# Zoning Staff Report

**Case Number:** ZC-24-154

**Request:** To: Amend “PD 1090” Planned Development for all uses in “D” High Density Multifamily to add new development standards for parking between building and street and carports between building face and street; site plan required (SP-24-015)

Director of Development Services: \_\_\_\_\_ Date: \_\_\_\_\_  
**Zale Rock Creek - Site Plan**  
Zoning Case No. SP-24-015  
Location: Fort Worth, Texas (No Address Assigned)  
Preparation Date: 11.08.2024

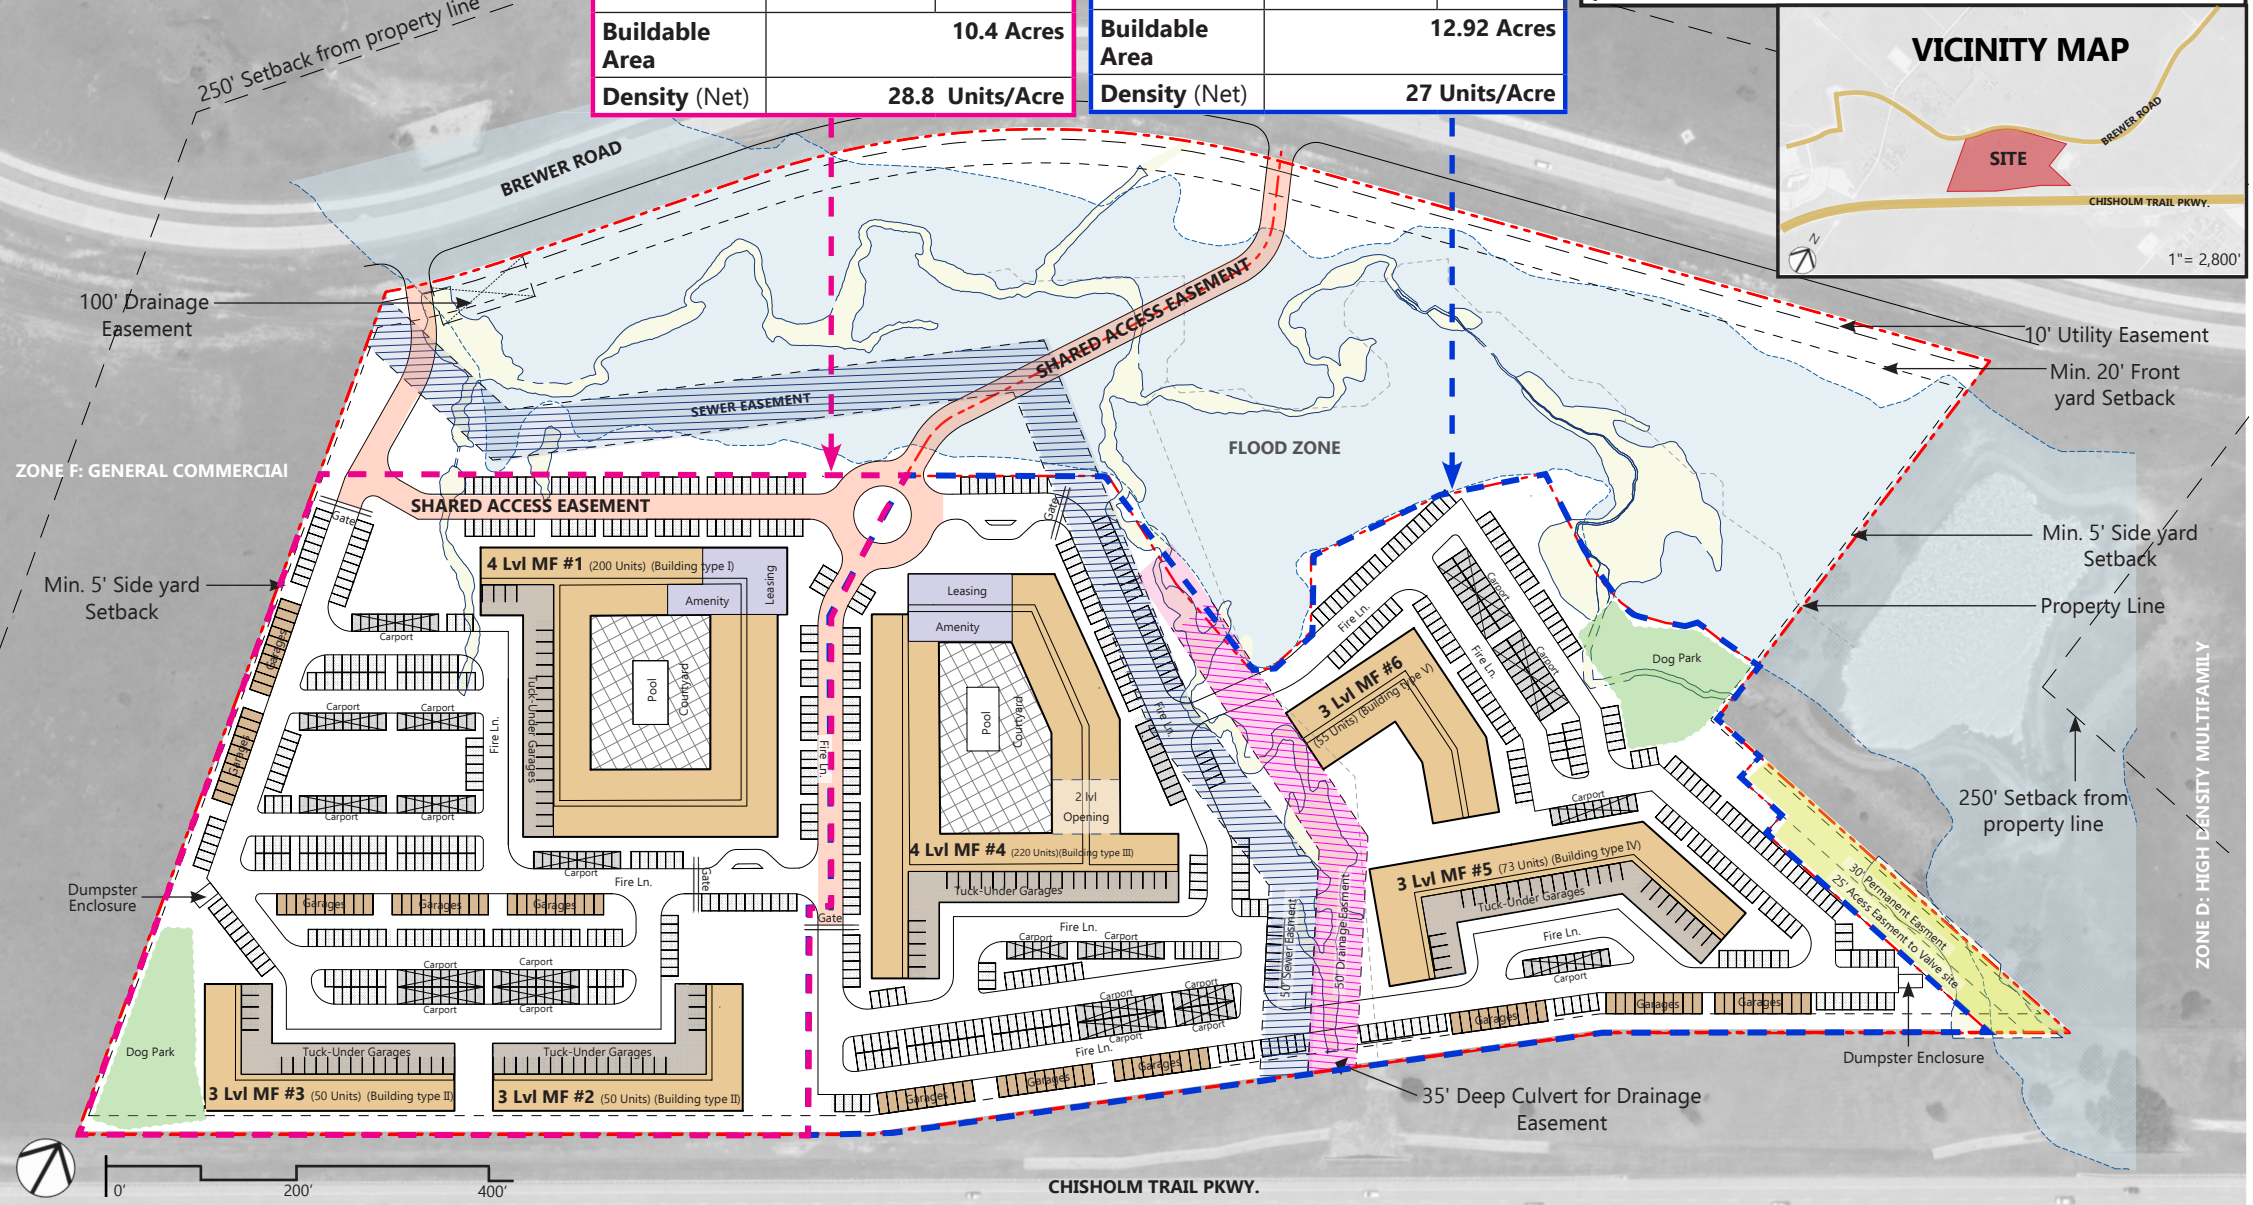
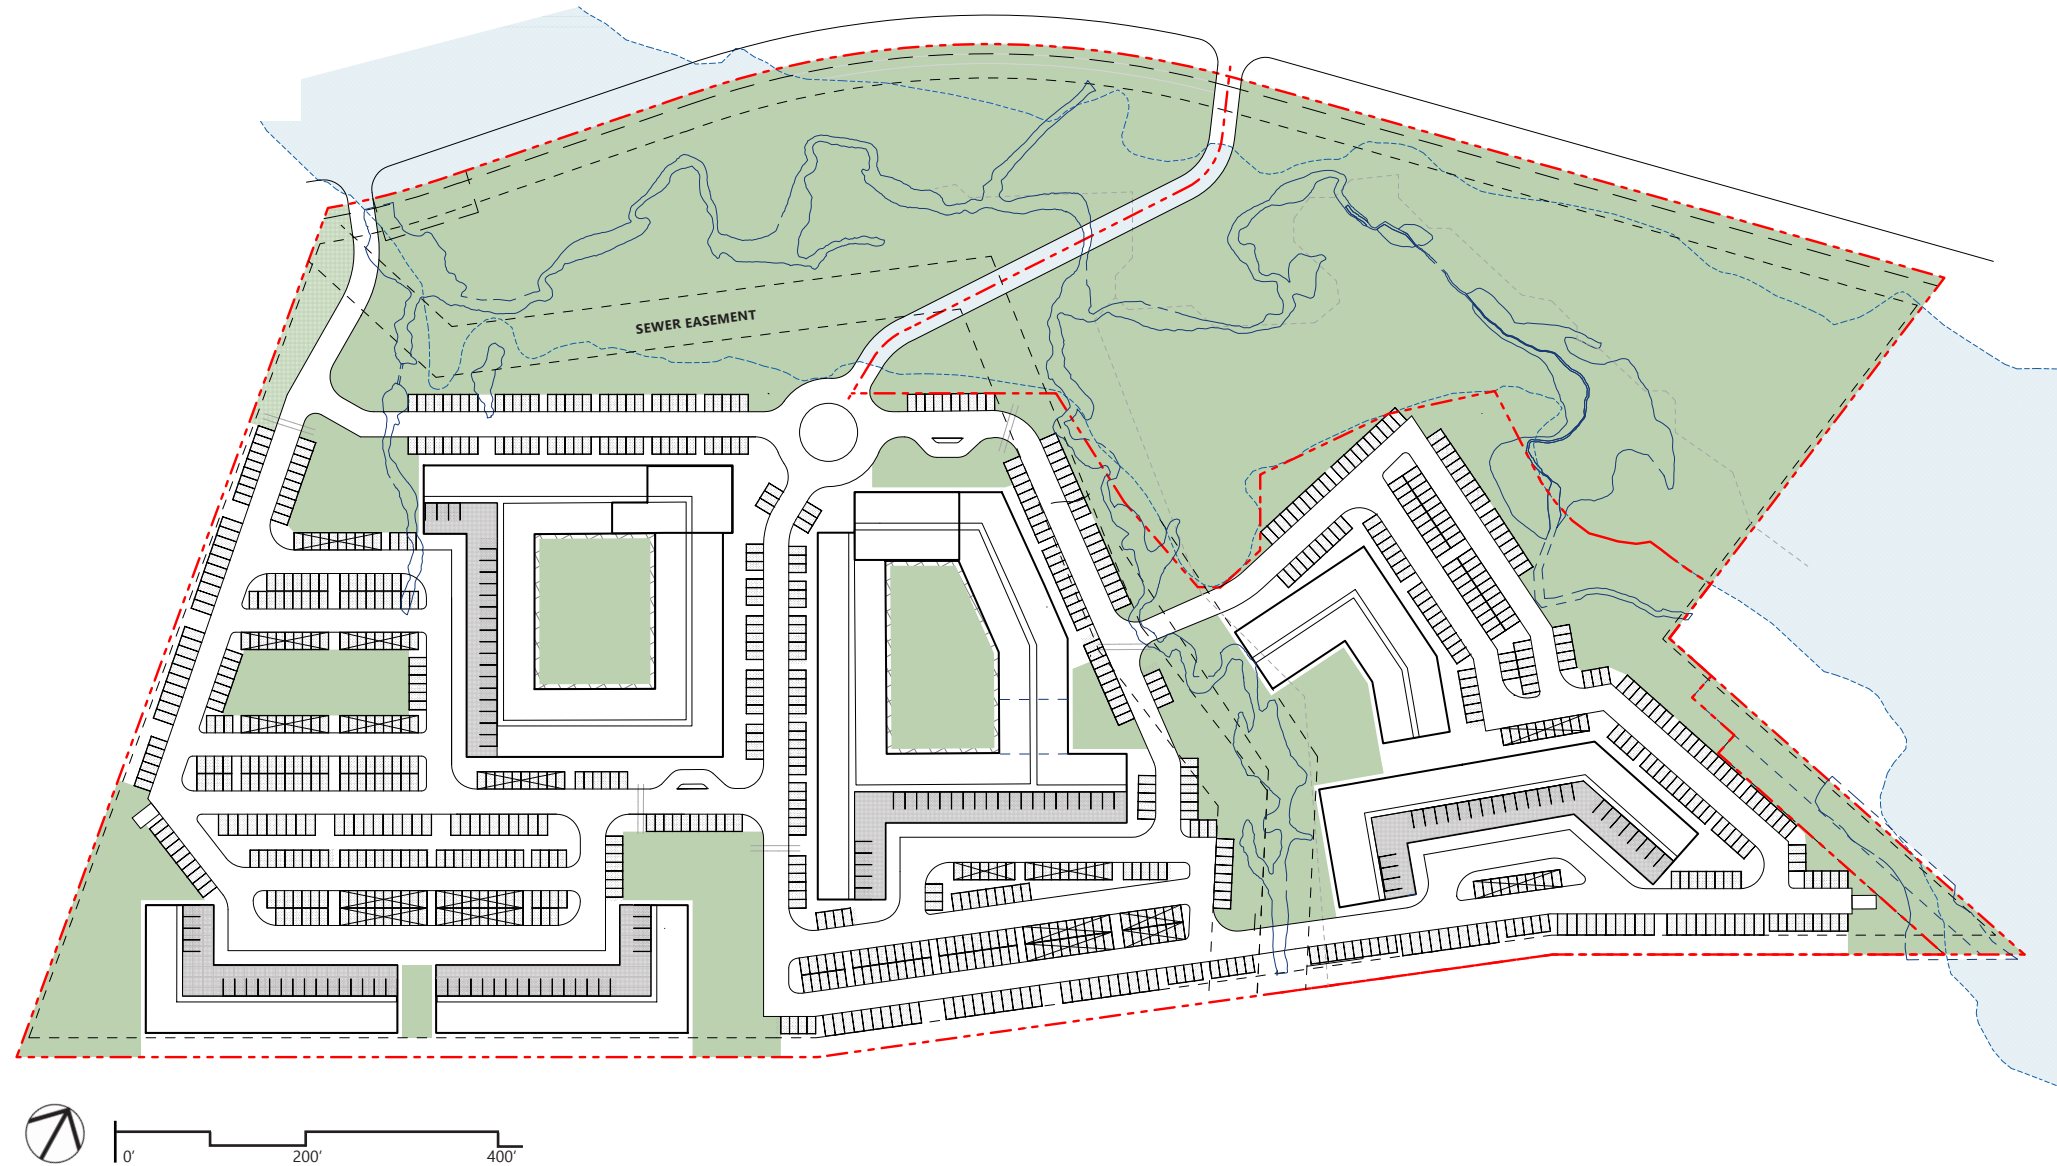
1. Front yard fence needs to be behind the front wall of the front yard building (a development standard will be needed for the PD)
  - b. Multifamily development. Fences shall not be located in the area between building facades and the property line. Frontage on a controlled access highway shall not be considered a street for purposes of this section. Perimeter security fencing is prohibited; however, security fencing is permitted on interior property lines. Solid screening fences are required when adjacent to a one or two family district unless adjacent to a public park or controlled access highway when a solid screening fence is not permitted and an open design fence shall be installed, if a fence is installed.

2. The maximum height setback from single-family is measured at the property line, indicate on the site plan where the measurement if less than 250.
3. Add the following notes to the site plan: Building façade and materials will comply with MFD standards
4. Phase 1 has no dumpster enclosure is one proposed please show on the site plan.
5. Carports are not permitted between building face and street (a development standard would be needed for the PD)
6. How are the shared streets classified, access easements? They need to be identified on the site plan.
7. Friendly reminder regarding open space, please make sure site complies

Internal Emergency Access Easements will need to be named. The Fire Department will assist you with that during the platting phase. I attached the standards for street names. Email Fireplatting@fortworthtexas.gov to request approval for street names prior to FINAL PLATTING. Please include the subdivision name and plat

Two points of access are required from projects having more than 100 units.

Fire lanes must be a minimum of 26' wide and provide hose lay to the exterior of each structure within 150', measured in a 5' wide unobstructed path from the edge of a marked fire lane or public street. That distance MAY be increased to 300' if the building is equipped with a fire sprinkler system.

Where divided by a median, fire lanes must be a minimum of 20' on either side of the median.

Vehicle gates are required to be a minimum of 20' wide when fully opened and equipped with Knox Locks. Permits are required.

? 600 ft. (300 ft. radius) of space between hydrants along a direct horizontal line.

? 500 ft. hose lay distance to all points of building.

FDC's for sprinkler and standpipe systems shall be located within 50 ft. of a dedicated street or fire apparatus access road and shall be within 150 ft. hose lay distance of the nearest fire hydrant. Each building shall be equipped with its own FDC, unless otherwise approved by the fire code official.

1. CFA will need to be executed per plat comments prior to final platting
2. Secondary ingress and egress to subdivisions. Multi-family developments of 100 dwelling units or more shall have a platted and constructed secondary ingress and egress to a public street. Ch. 31-101(c)(1) and (3)
3. Sidewalk connections throughout the development and from the development to Brewer are recommended

1. FYI--Only a portion of the property shown on this site plan is included in a final plat FP-24-147. The remainder of the land will need to be preliminary platted and then final platted since it is included in an approved concept plan. No building permits for any portion of this development can be issued until the associated final plats for this property have been recorded at the Courthouse and addresses have been assigned by the Fire Department.
